Bulletin Level: 2*

Subject: Sticking of 200A 24V (56317116) and 36V (56395453, 56413516) Contactors

Models Affected: Warrior ST (all models), 34RST (all models), BA 755/855 (all models), Adhancer (rider all models), AquaRide (all models), Advenger (all models), Adphibian (all models), AquaPLUS (all models), Adgressor (all models), Condor (all models), BR 600S/700S/800S (all models), BR 850S/950S/1050S (all models), BR 1100S/1300S (all models), BRX 700 EDS.

Figure 2

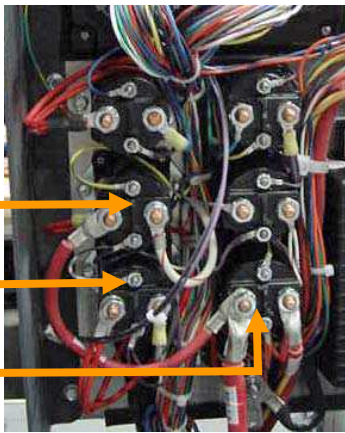
If the issues above are reported and the date code of the contactor is within the suspect range (see Fig.1), replace the contactor. Affected date codes (see Fig.2 for location) range as follows:

Location of date code

Condor & BR1100/ 1300* :

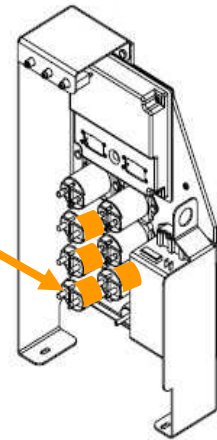
Remove control panel cover to access contactors. The **200A units** are larger than the 100A units and are located as shown in the following illustrations depending upon your machine.

K2
right brush motor

K3
center brush motor

K7 main

* alternate configuration
K4 left brush

Adphibian, AquaPLUS:

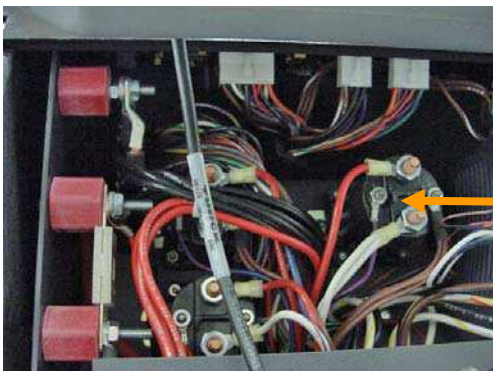
K2
vac
motor

Advenger, AquaRide, Adhancer Rider, BRX 700, & BR600/ 700/ 800:

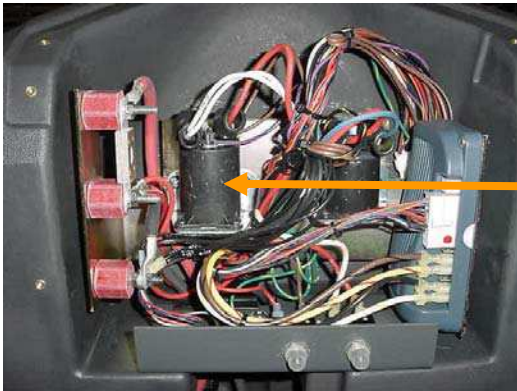
K2
vac
motor

Warrior ST, 34 RST, BA 755/ 855:

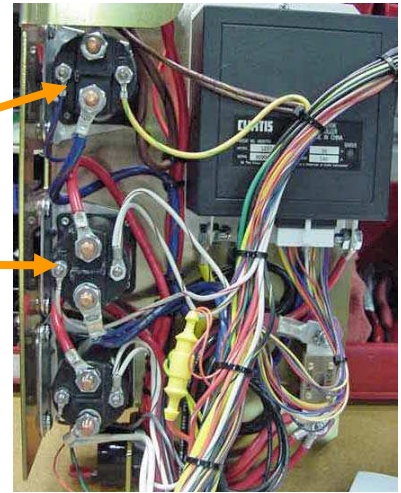
K1
brush
motor
